Central Electricity Authority (Flexible operation of Thermal Power Plants) Regulations, 2022 [Draft]

CER Opinion

Figure 1: Comparison of Rihand (Low VC) and Dadri Thermal (High VC)

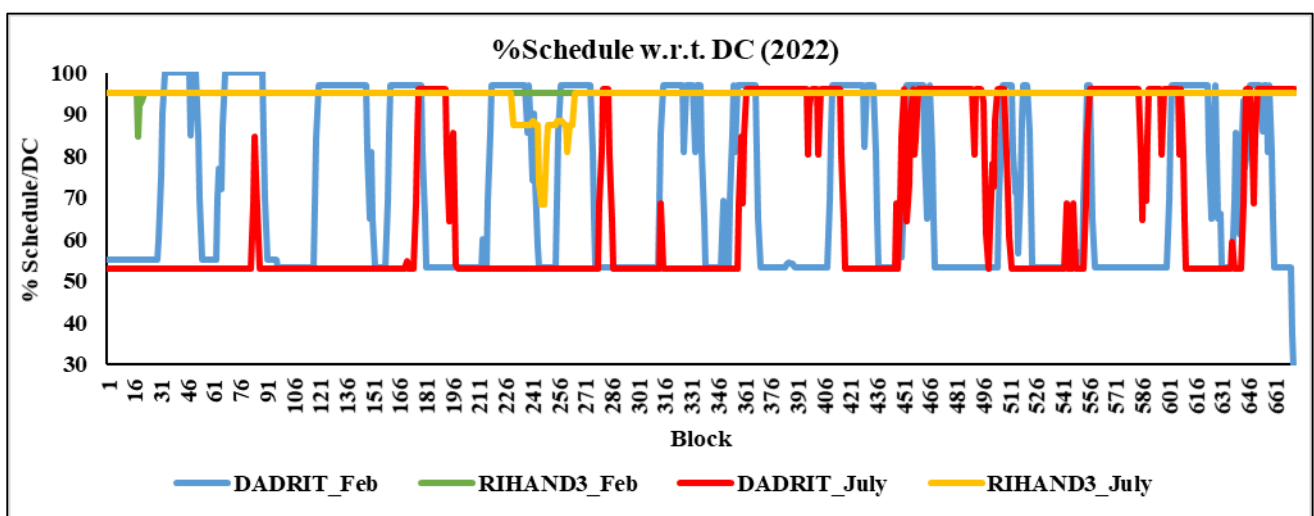
EAL analyzed that percentage of schedule with respect to the declared capacity for ISGS Rihand (low VC) and Dadri TPS (high VC) for the first week of February and July, 2022. It is evident that the schedule of Dadri TPS is changed more frequently as compared to that of Rihand TPS. Dadri TPS is scheduled at 55% of its declared capacity; whereas Rihand TPS (lower VC plant) is operated near to its declared capacity during the period considered. Thus, it may be inferred from this analysis that the thermal power plants with higher VC are required to be retrofitted with the necessary modifications for flexible operation as compared to plants with lower VC.

It is further suggested that all new TPPs (COD not yet declared), if expected, should be mandated for implementation of measures for flexible operation of power plant. Existing power plants with high variable cost (VC), which are required to operate at levels less than their available capacity *i.e.*, at minimum power level and/or are required to have higher ramping capability for safe system operation may be targeted on priority for implementation of measures for flexible operation.

Figure 2: Scheduling of Low VC thermal power plant for February, 2022

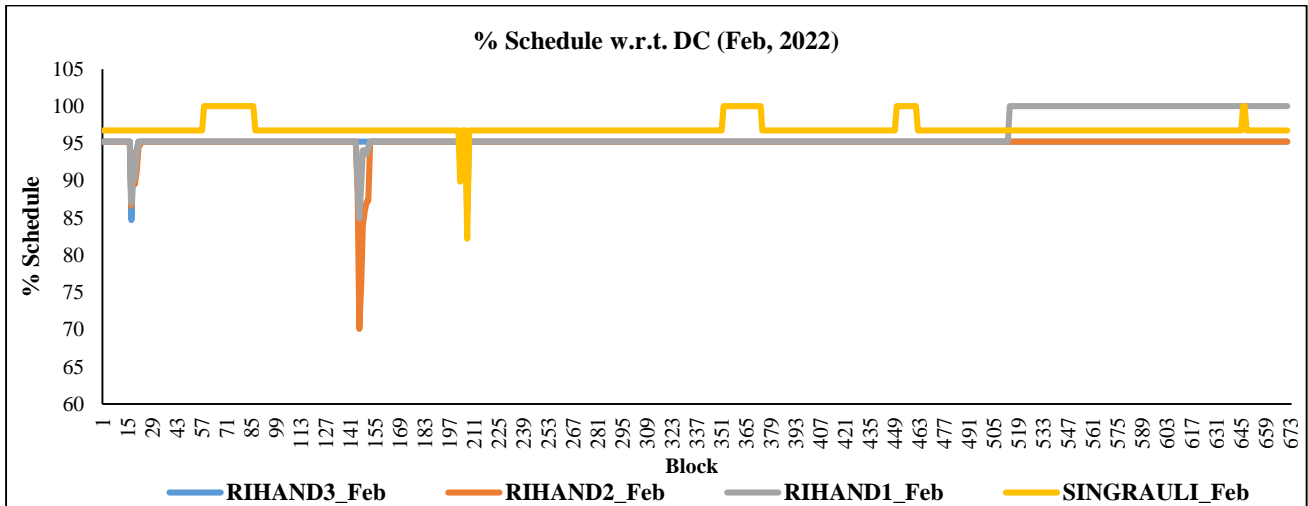
From the following figures (2 & 3) it is observed that power plants with low VC are scheduled at almost 100% of their Declared Capacity, with few blocks witnessing 70% schedule. As such, it may be inferred that these power plants may not require additional investment for further increment in ramp rate and decrease in minimum power levels (MPL)
